MAINE TURNPIKE

MAINE TURNPIKE AUTHORITY

CONTRACT 2007.07
MAINE TURNPIKE AUTHORITY
ADMINISTRATION BUILDING
SET 2 OF 2

F1 | DUCTBANK DETAIL
NOT TO SCALE

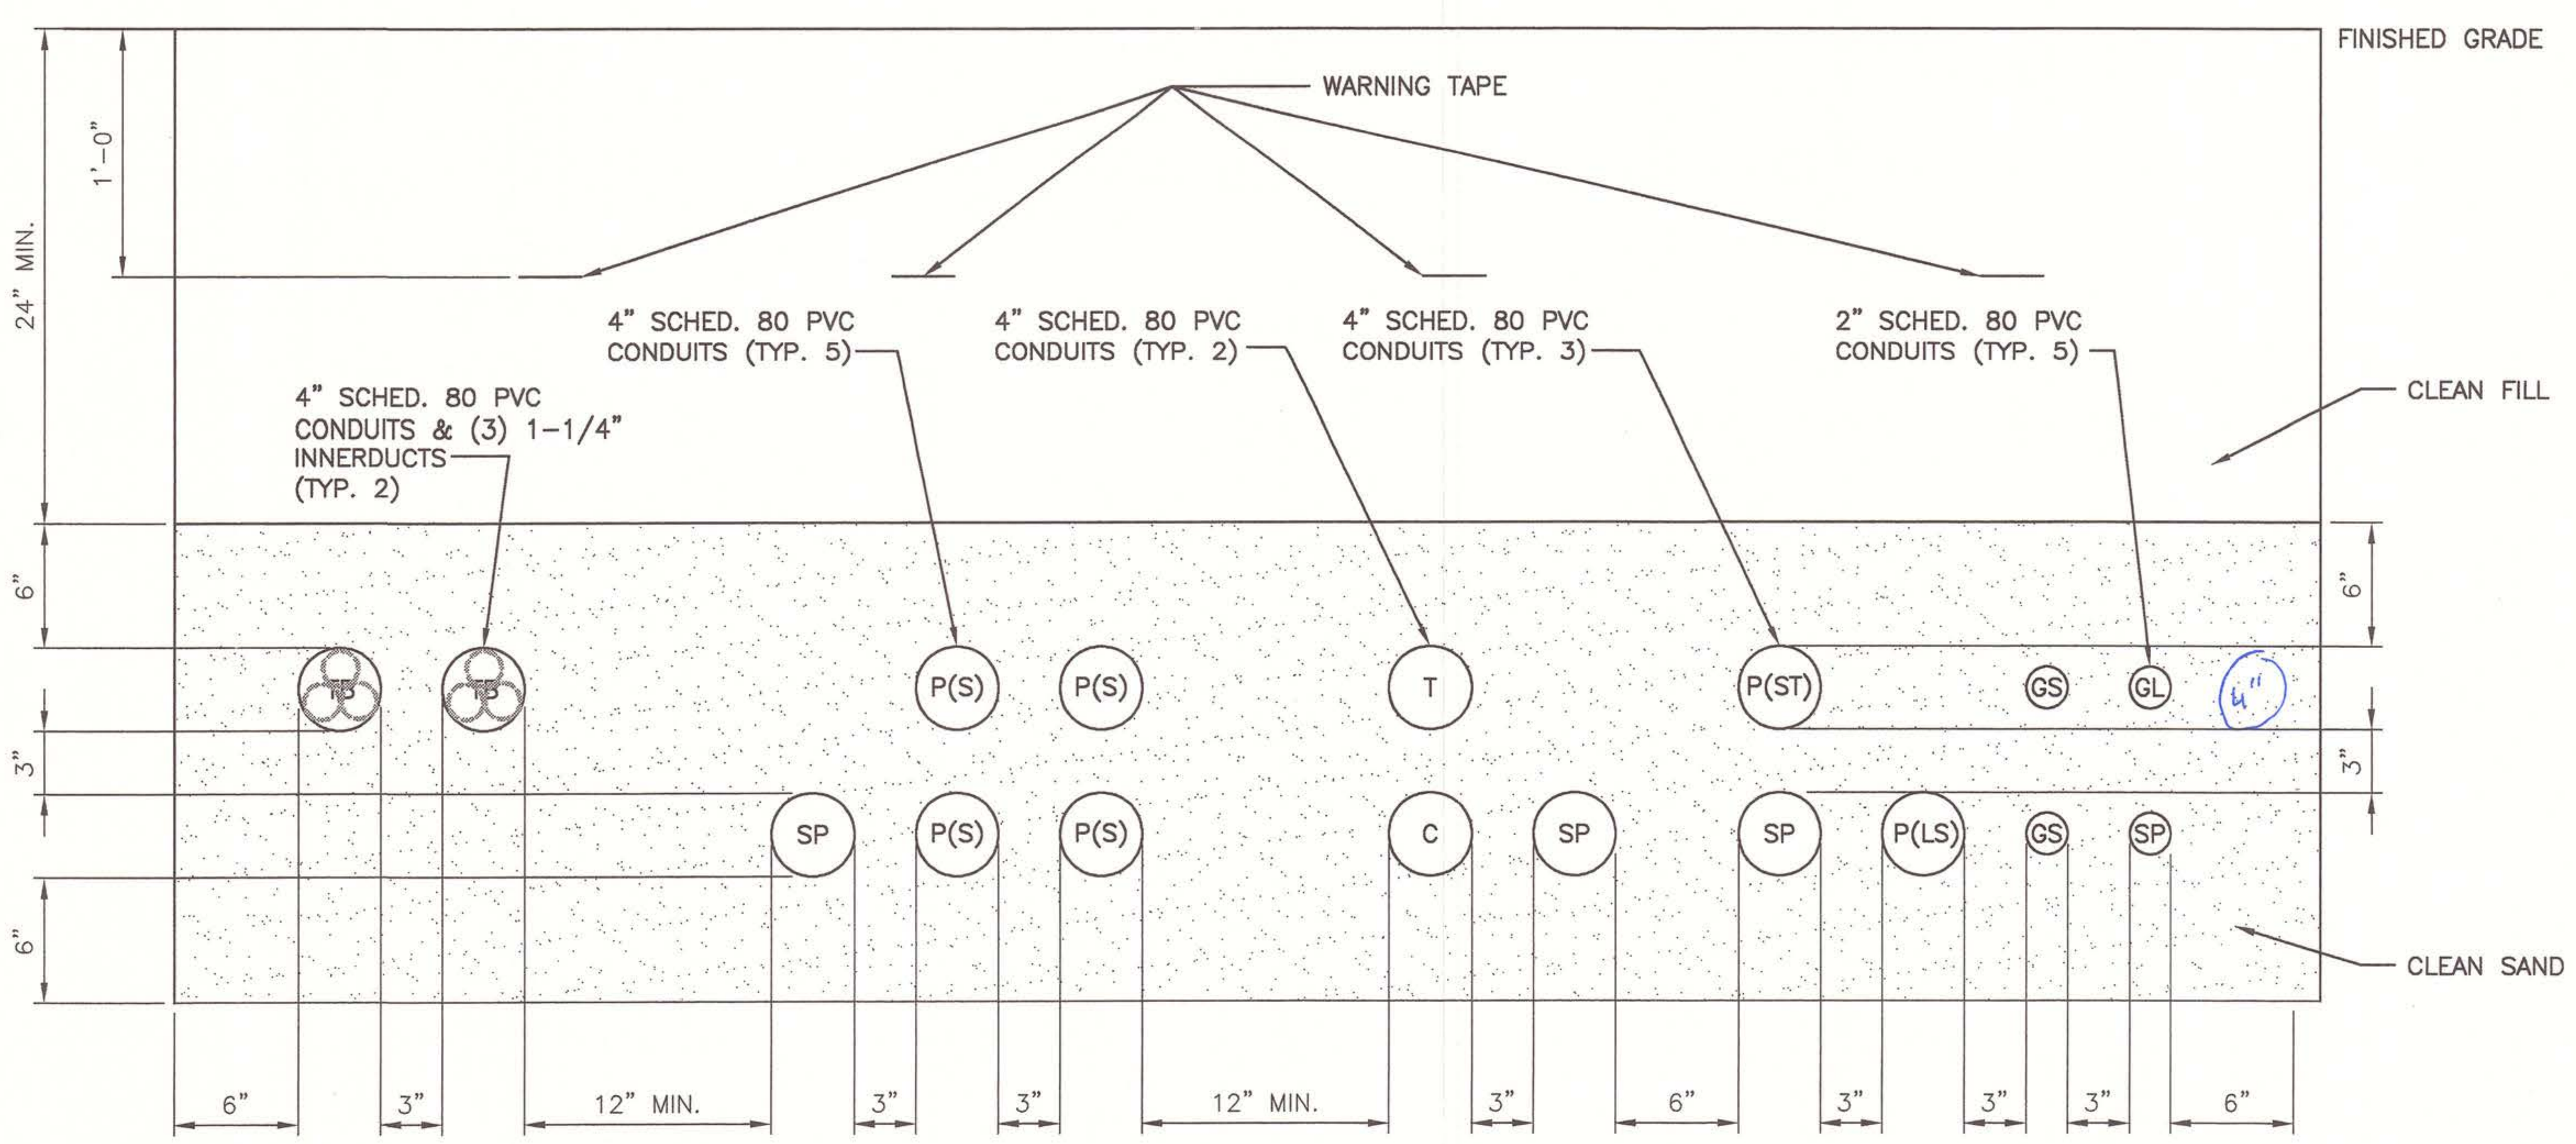
15. ES302 – DUCT BANK DETAILS:
a. Detail A1: Revise note to read "Provide concrete encasement beneath all paved areas subject to vehicular traffic, including paved drives and parking areas."

EY102 – SECOND FLOOR SYSTEMS PLAN:

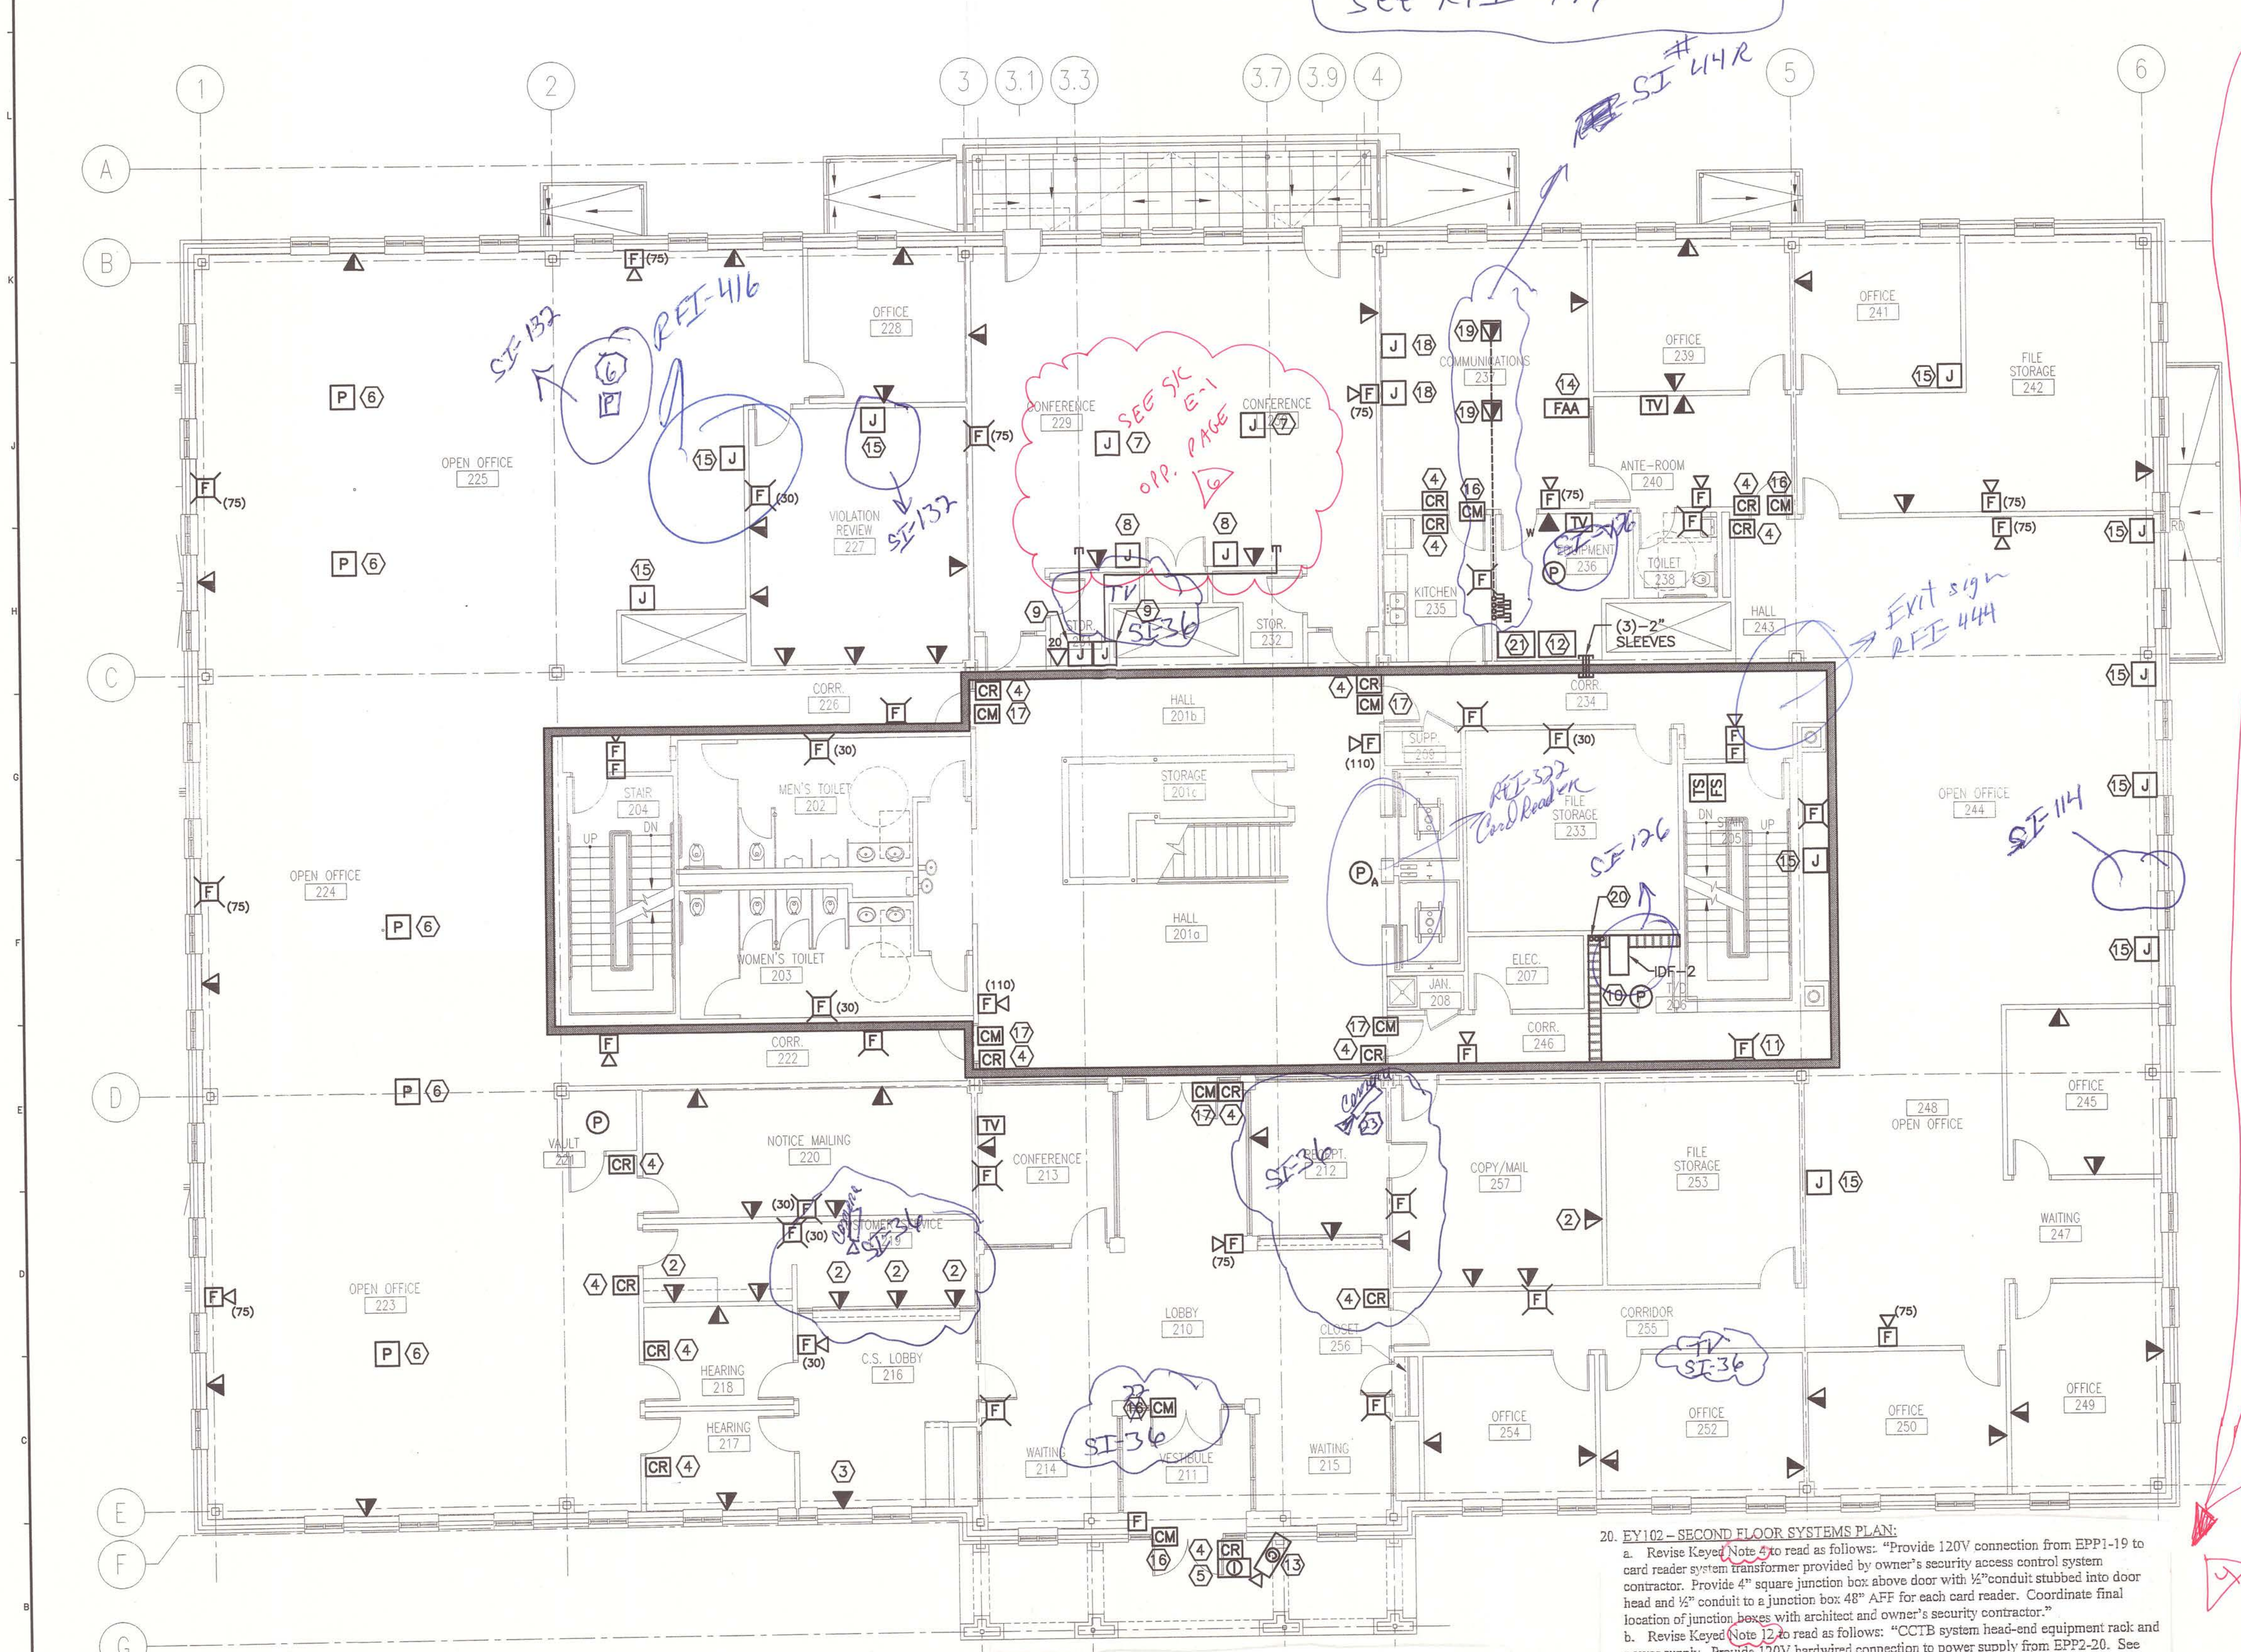
a. Revise Keyed Note 12 to read as follows: "Not Used." Associated equipment location in Equipment Room #236 shall be removed. This direction shall supercede all prior direction given in the bidding documents, including prior addendum.

c. Revise Keyed Note 13 to read as follows: "Furnish and install fixed CCTV camera in recessed dome beneath canopy. Reference drawing EY652, as modified herein by Sketch No. E-3, for CCTV riser diagram and power supply. Coordinate final mounting location and aiming with owner and architect.
